Clinton Power Station

Clinton Power Station, Unit 1
Facility Operating License No. NPF-62
NRC Docket No. 50-461

Subject: Request for Amendment to Technical Specifications to Permit Inclined Fuel Transfer System Blind Flange Removal During Power Operations

Figure 1

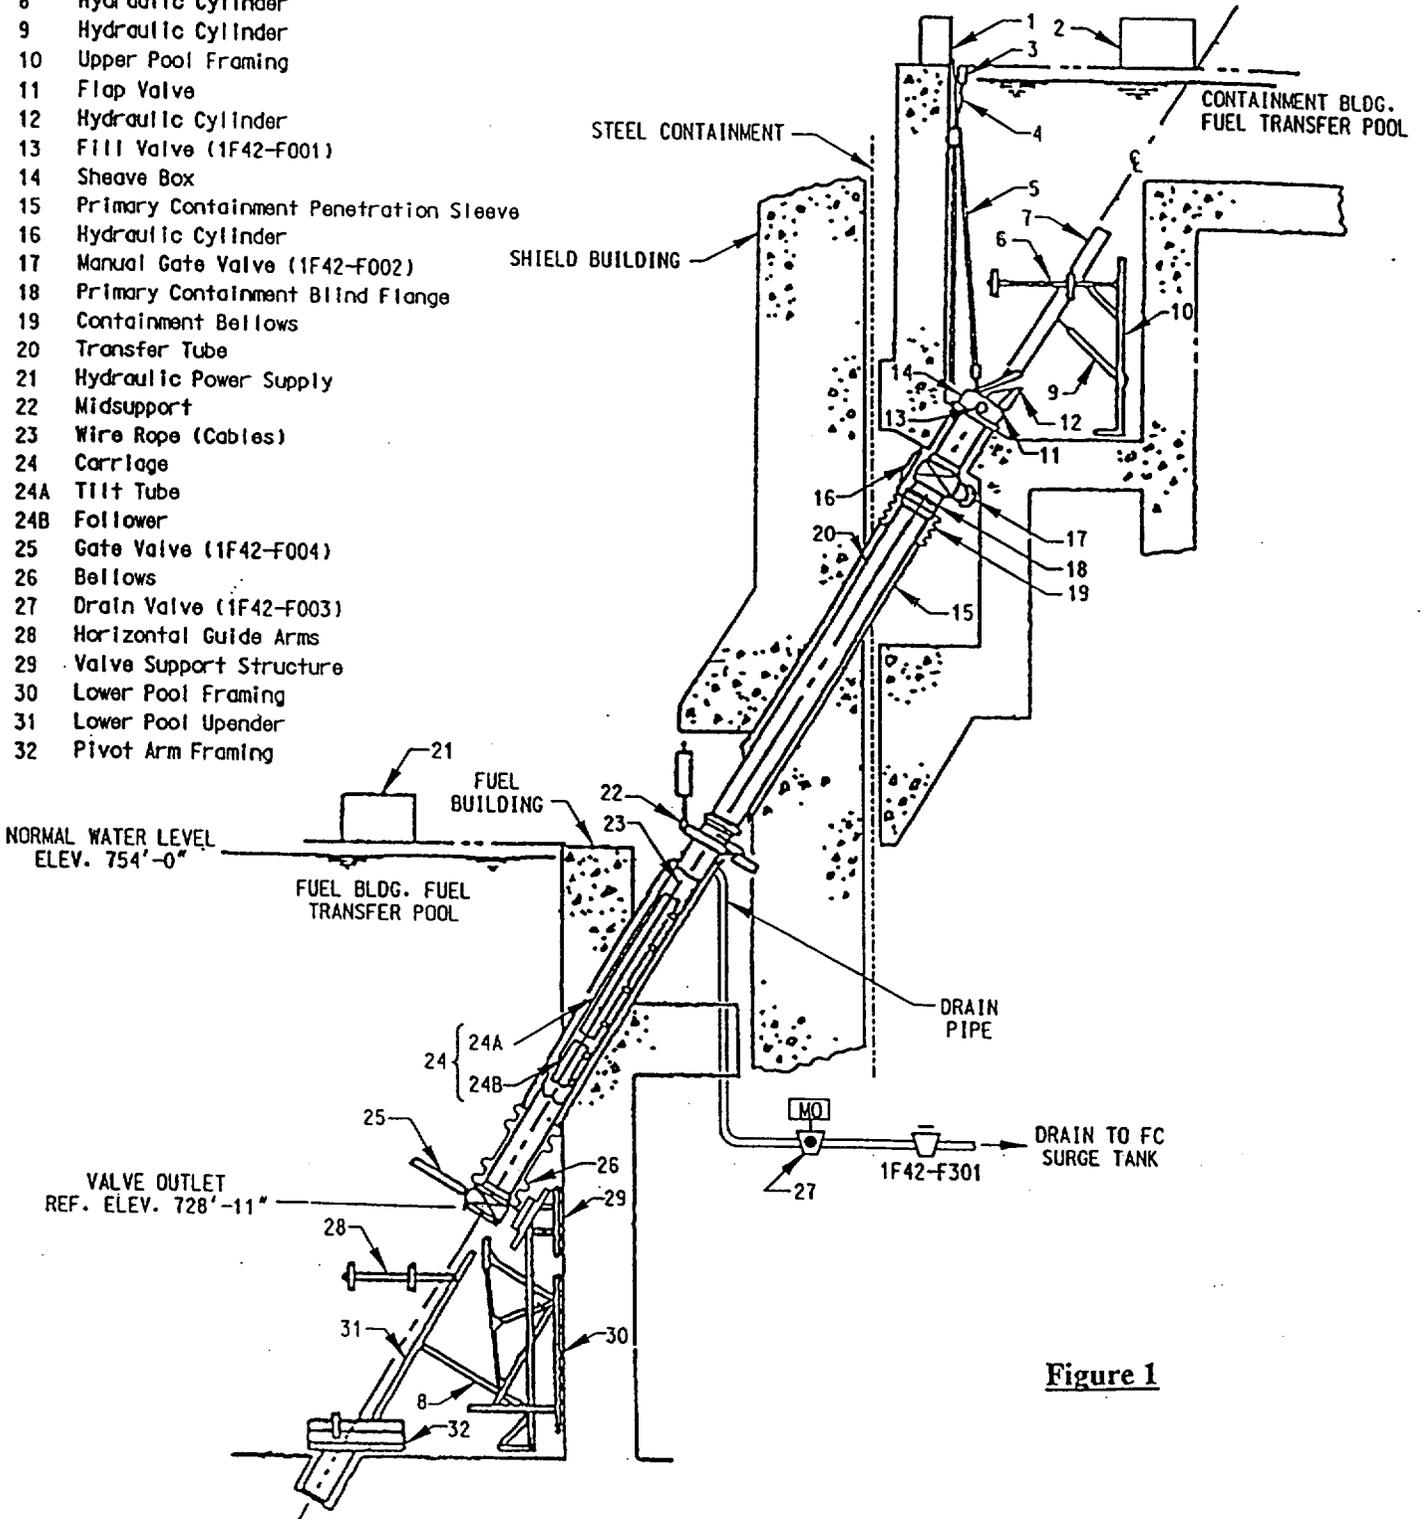
The IFTS at CPS (Figure 1) is used to transfer fuel assemblies, control rods, defective fuel storage containers, and other small items between the pool in upper primary containment and the lower-elevation pool in the adjacent fuel building (i.e., secondary containment) by means of a carriage traveling in an inclined transfer tube. The IFTS is a fixed installation, consisting of the inclined fuel transfer tube, upper and lower upenders, hydraulic power units, an electrically powered winch, carriage, and instrumentation required for the control system that includes redundant inputs for status indicators, and both a manual and semi-automatic programmable computer control facility.

The transfer tube (Figure 1, Item 20) is a 23-inch internal diameter stainless steel pipe, and provides a sealable, enclosed path for the carriage which is lowered and raised by means of a winch assembly. In the primary containment pool (i.e., upper pool), the transfer tube connects to the pool penetration and to a sheave box. The position of the carriage in the tube is tracked by a calibrated position system. The transfer tube is suspended between two flexible seals, or bellows. The transfer tube includes a valve at both ends, and is provided with a primary containment isolation assembly. The valve at the upper end, known as the flap valve (Figure 1, item 11), consists of a 24-inch disc with an actuating cylinder (Figure 1, item 12) and is mounted on the sheave box (Figure

The primary containment isolation assembly consists of two pipe spools separated by a removable blind flange (Figure 1, item 18) that is connected to the primary containment penetration via a flexible metal bellows (Figure 1, item 19). The blind flange normally forms a part of the primary containment boundary. Before the IFTS can be placed in operation, the containment isolation assembly must be disassembled and the flange replaced with a gasketed ring, and reassembled. The spring hanger and snubbers (Figure 1, item 22) at the mid-section of the transfer tube provide support and seismic restraint for the system. At the connection of the two transfer tube sections, the 4-inch drain line and the "tube-drained" liquid level sensors are installed.

With respect to the IFTS and its associated containment penetration, containment operability is made by the blind flange (Figure 1, item 18), containment bellows (Figure 1, item 19), and the steel containment penetration. Special gaskets are provided for leak checking to assure containment isolation. Installation of the blind flange is the normal

method for ensuring primary containment isolation is effected for the IFTS. However, as approved by the NRC in Amendment 107 (Reference 1), adequate isolation of the IFTS containment penetration is achieved by taking credit for the fact that the IFTS transfer tube terminates deep in the fuel building fuel transfer pool. The conditional note approved in Reference (1) and the proposed note described above require that the fuel building fuel transfer pool level be maintained at a certain height. This requirement is implemented by plant procedure. Maintaining a high level of water above the lower end of the IFTS tube effectively seals the tube and precludes it from becoming a potential leak path for containment atmosphere into the fuel building in the event of a design basis accident. This provided a basis for permitting the flange to be removed to support IFTS testing and maintenance during plant operation.

Based on the evaluation documented in Reference (4) as described above, the removal of the IFTS blind flange in Modes 1, 2, or 3 for testing, maintenance and moving new fuel for up to 40 days during an operating cycle, does not adversely affect the ability to provide effective containment isolation when required.
